## 2EDGKD-5.08 Engineer Amendment Notice

### 1. Amendment Item:

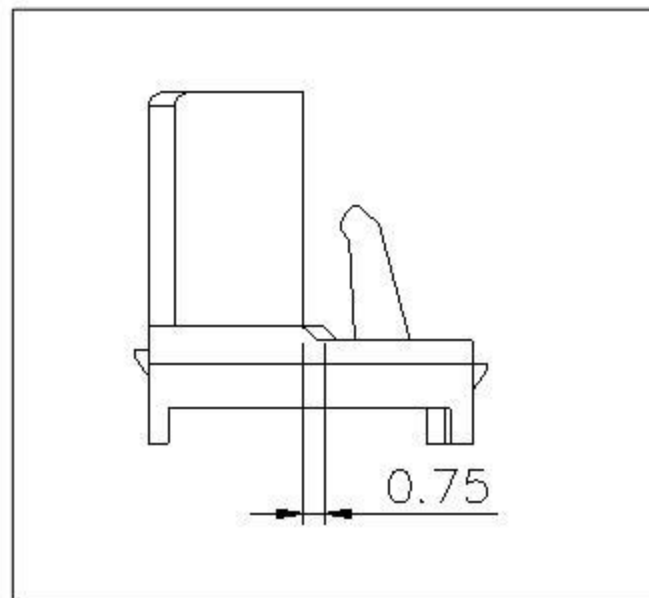
The fixing buckle was broken .so we add an R angle structure which can make the buckle solid and stable.
